City of Denton

Meeting Agenda Planning and Zoning Commission

Wednesday, May 13, 2026

- A. [FP26-0012b](#) Consider a request by Mack Mattke of Kimley Horn & Associates on behalf of CATDENTON 35 for a Final Plat of Summit 35 Addition. The approximately 68.175-acre property is generally located east of North Interstate 35, north of Loop 288, and southwest of Highway 77 (North Elm Street) in the City of Denton, Denton County, Texas. (FP26-0012b, Summit 35, Julie Wyatt)

Contact: Andrew Pieper
OWNER MAILING
ADDRESS:
9800 Hillwood Pkwy, Suite 300,
Fort Worth, Texas 76177

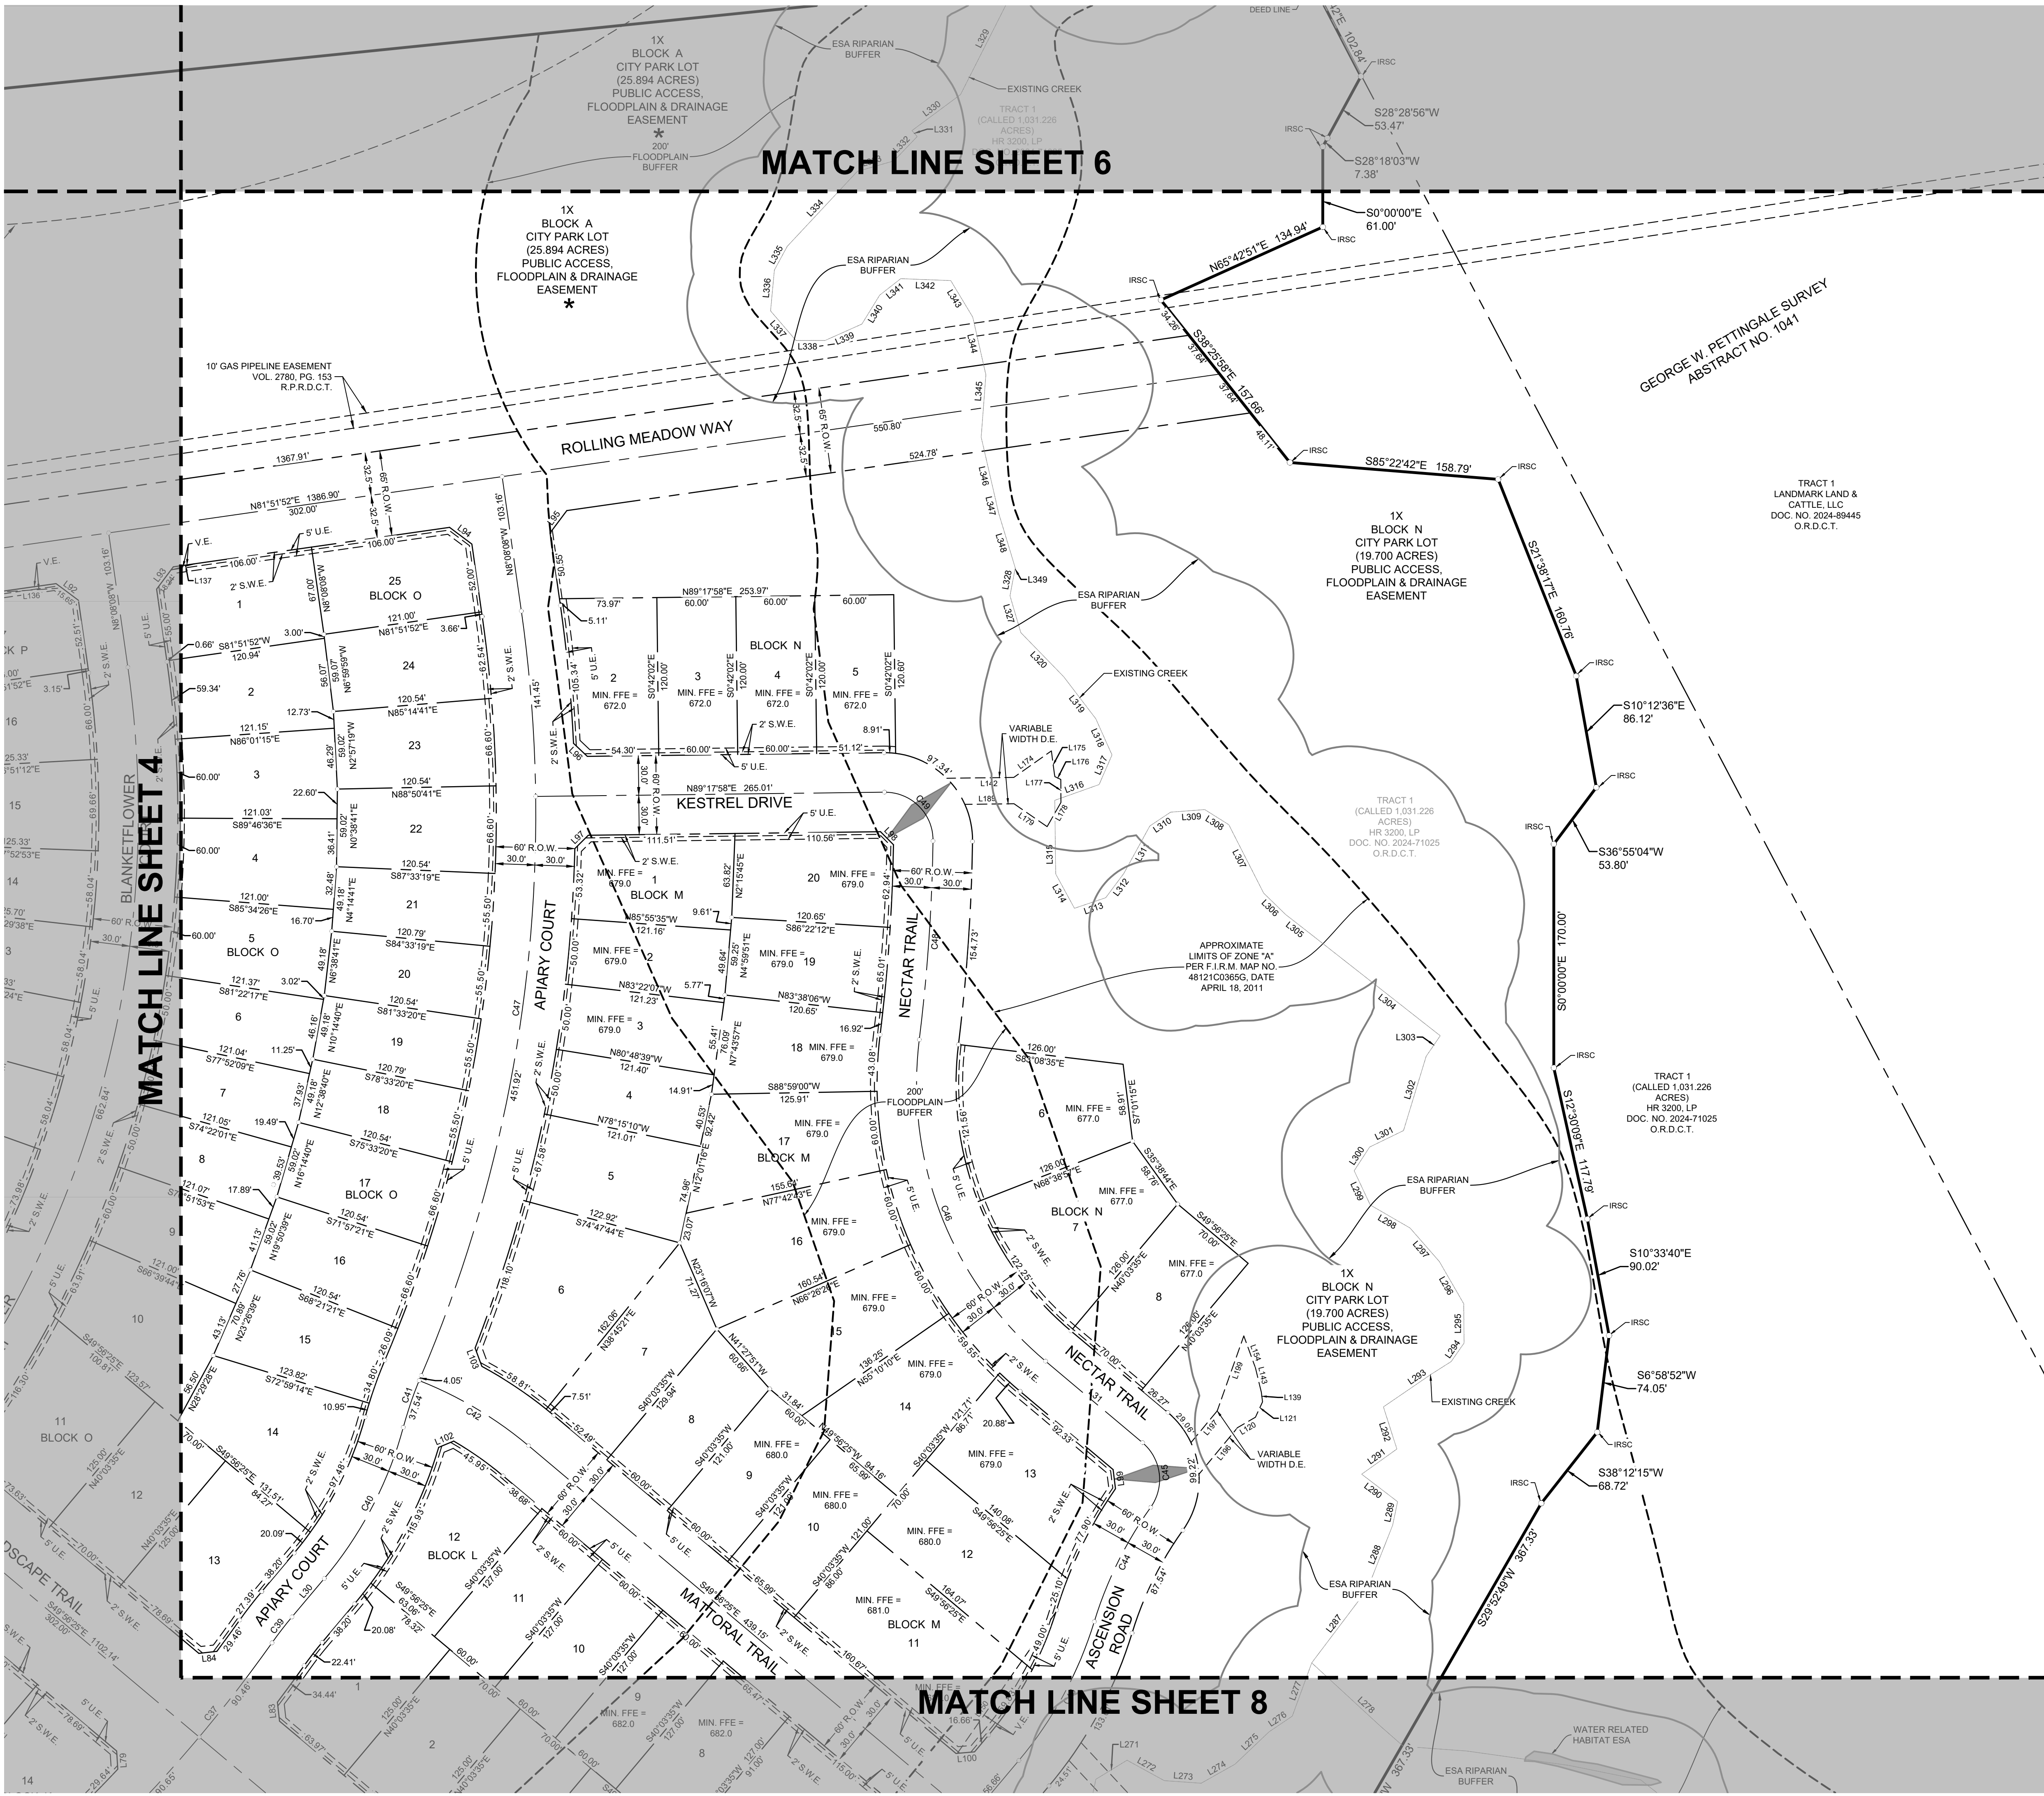
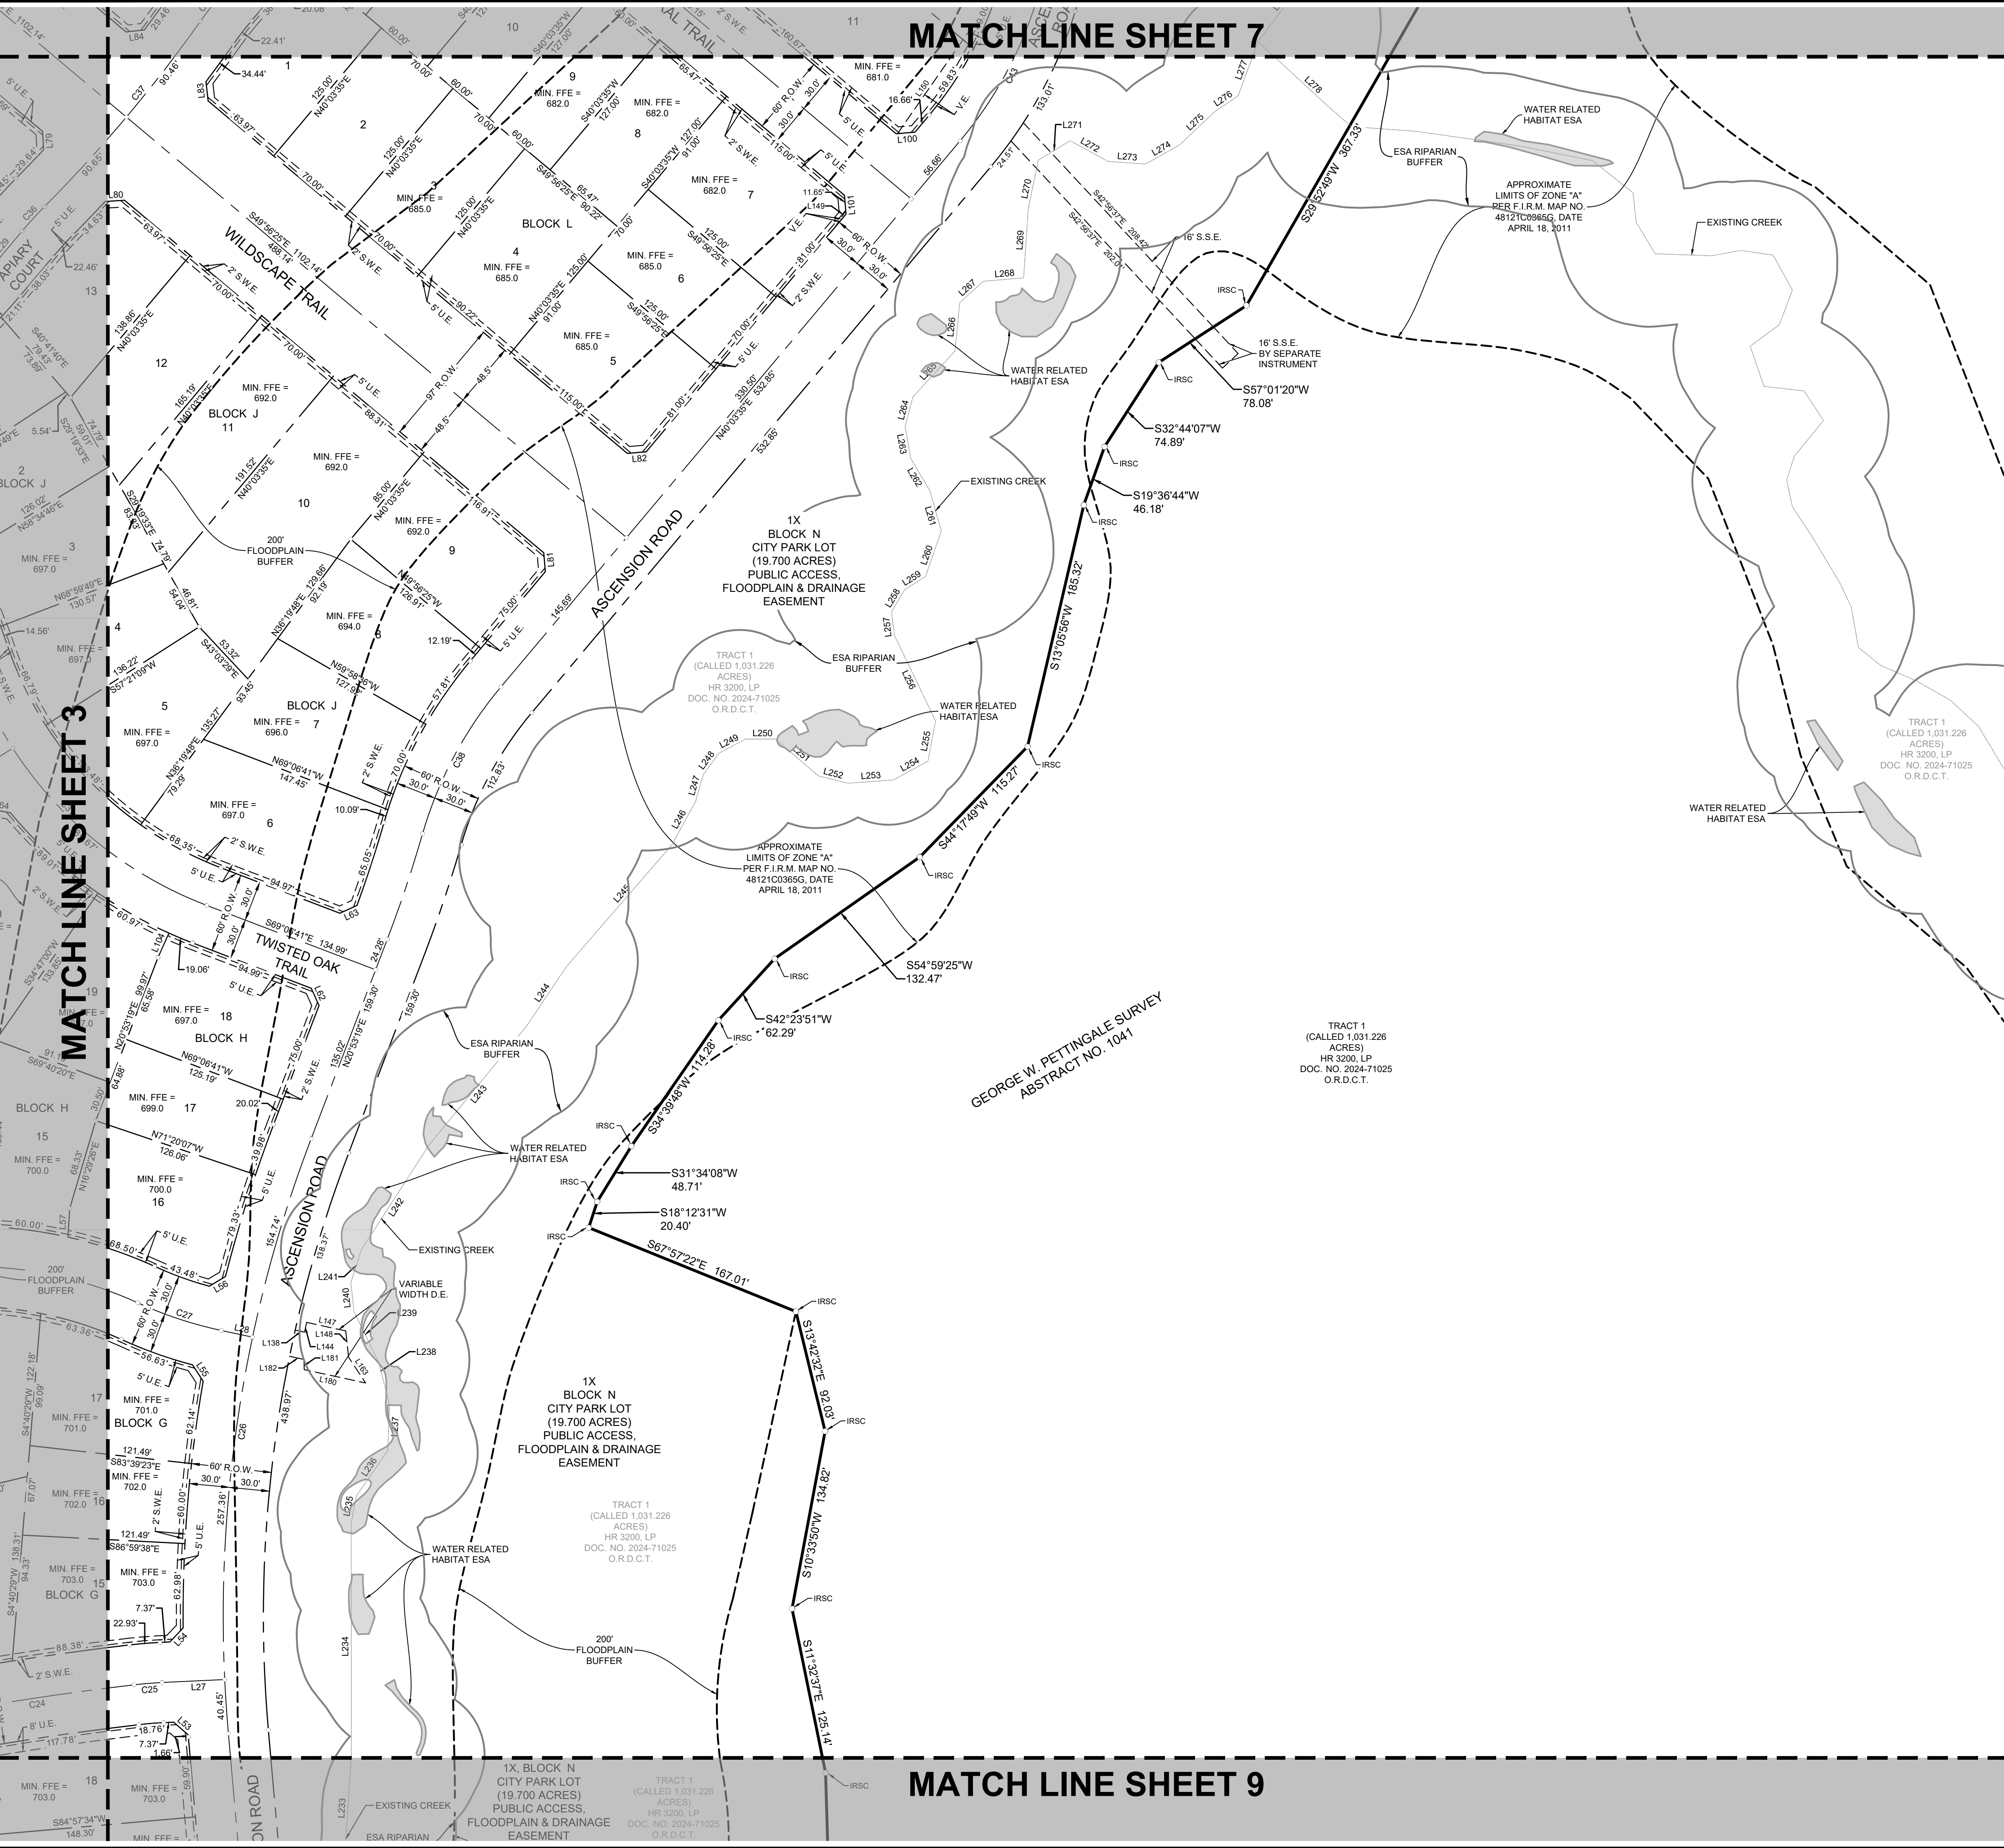
1. Compliance with MPC19-0002c 2.11.4C.2.d, which requires final approval of the Civil Engineering Plans (CEP25-0082), must be achieved prior to final approval.

1. Compliance with MPC19-0002c 2.11.4C.2.d, which requires final approval of the Civil Engineering Plans (CEP25-0082), must be achieved prior to final approval.

4. Compliance with this DDC				
a. The proposed development shall comply with all applicable standards in this DDC, unless the standard is to be lawfully modified. Findings:		☐	☒	☐
